RENESAS TECHNICAL UPDATE

Product Category	MPU & MCU	Document No.	TN-RX*-A076A/E	Rev.	1.00
Title	Corrections to the RTC Clock Setting Procedure in RX210 Group User's Manual: Hardware		Information Category	Technical Notification	
Applicable Product	RX210 Group	Lot No.	Reference Document	RX210 Group User's Manual: Hardware Rev.1.40 (R01UH0037EJ0140)	
		All

This document describes corrections to the clock setting procedure in section 26, Realtime Clock (RTCb) of RX210 Group User's Manual: Hardware rev.1.40.

Figure 26.3 Clock Setting Procedure

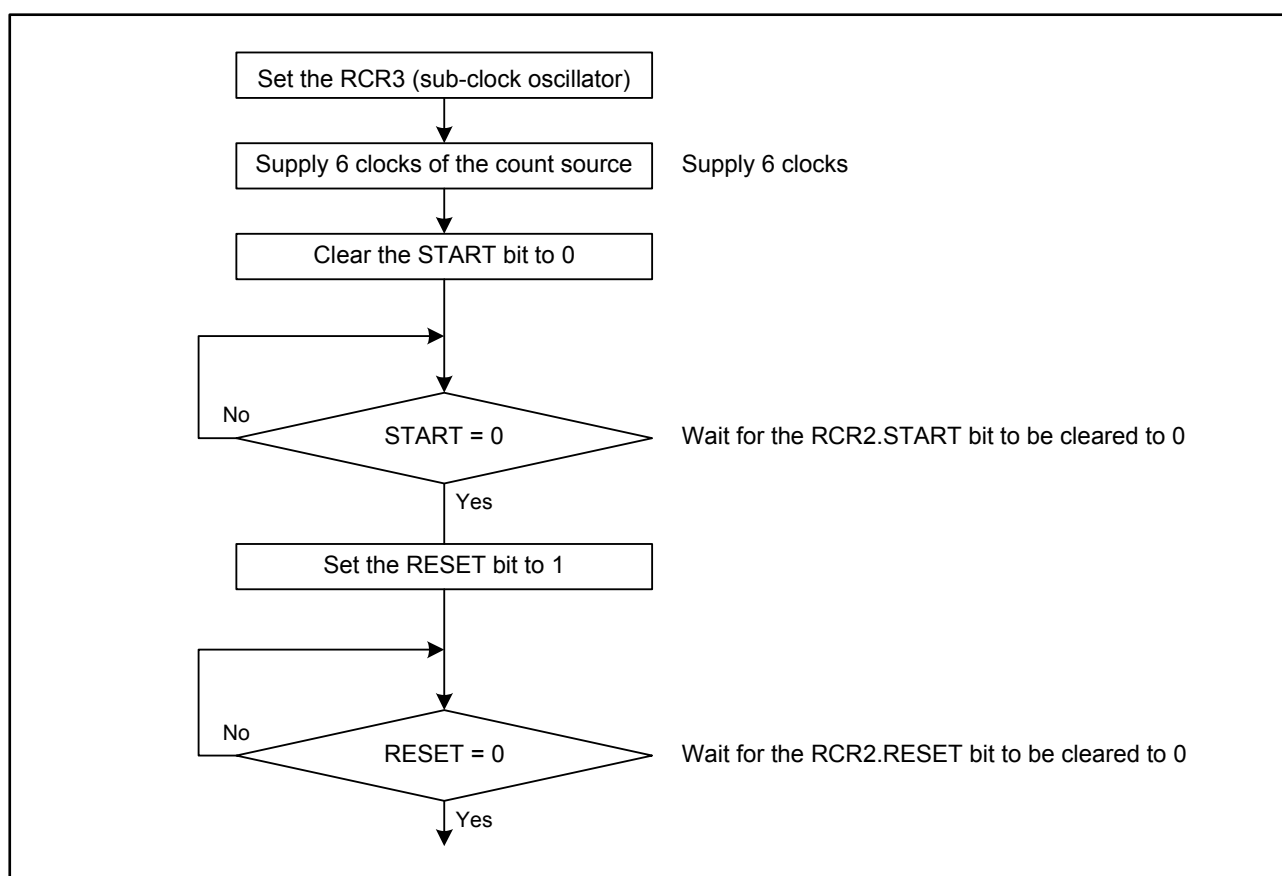
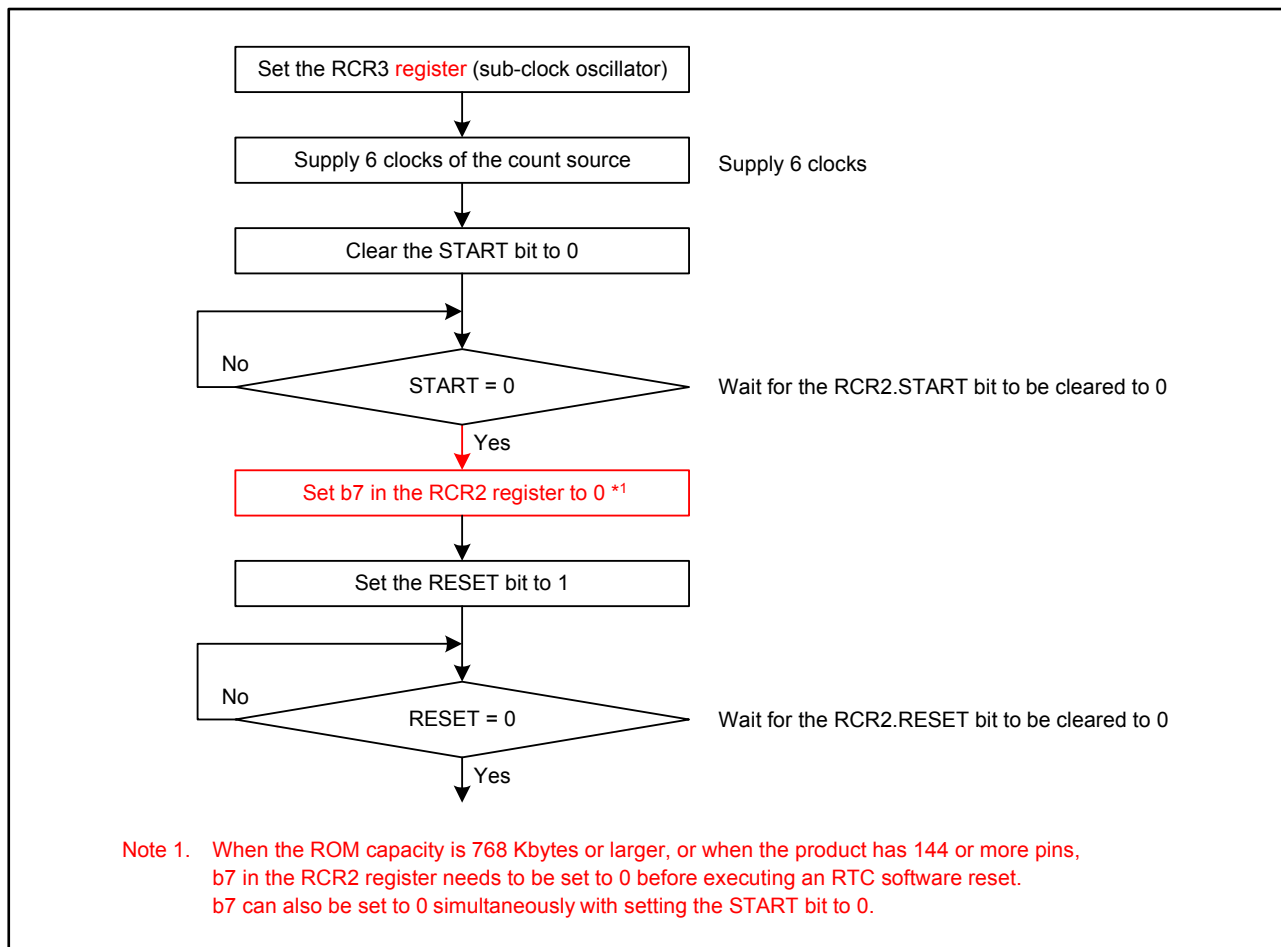
Figure 26.3 is corrected as follows:
